REMARKS

Amendments to the Drawings:

The attached sheet of drawings includes changes to FIG. 1. The replacement sheet, which includes FIGS 1 and 2, replaces the original sheet including FIGS 1 and 2. The annotated sheet shows, in FIG. 1, the change in which the polarities of the inputs of the amplifier 111 are reversed.

FIG. 1

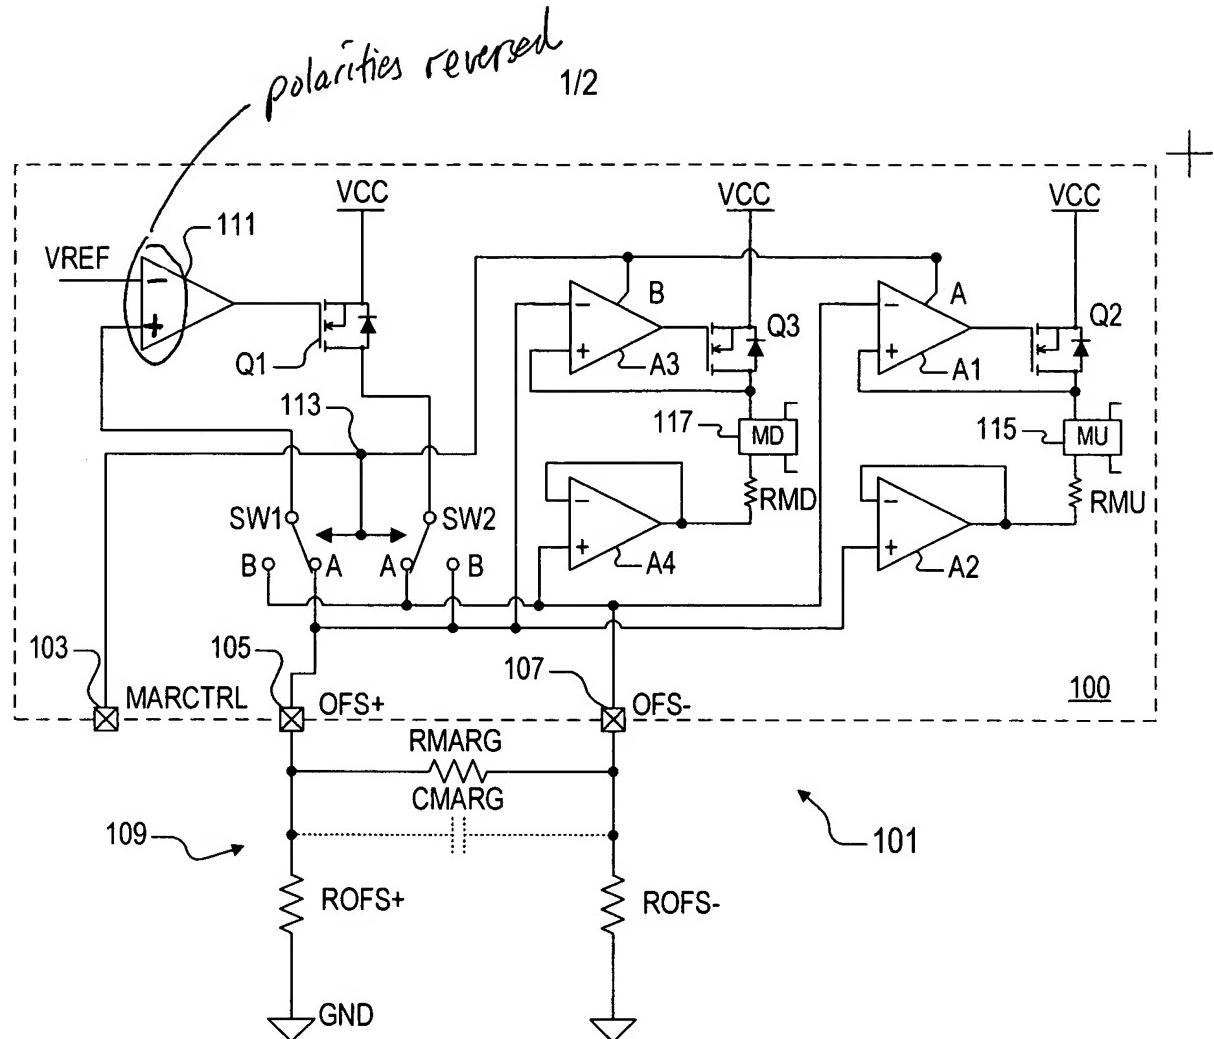
In the application as filed, the input polarities of the amplifier 111 of FIG. 1 were inadvertently reversed. The VREF signal was intended to be provided to the inverting input (e.g., the “-” or negative input) of the amplifier 111 rather than to its non-inverting input (e.g., the “+” or positive input). Also, the non-inverting input of the amplifier 111 was intended to be connected to the common pole of the switch SW1 rather than the inverting input of the amplifier 111. A replacement sheet for FIGS 1 and 2 is attached hereto including FIG. 1 with the input polarities of the amplifier 111 reversed. An annotated sheet is also attached herewith which shows the change and a brief description of the change in red.

Also, original paragraph [0024] of the application as filed is replaced with an amended paragraph, which is substantially the same as the original paragraph except that the references of the inverting and non-inverting inputs of the amplifier 111 are swapped to correspond with the proposed amendment to FIG. 1. Applicant respectfully submits that this polarity reversal was a typographical error when translating the Figures and that one skilled in the art would understand
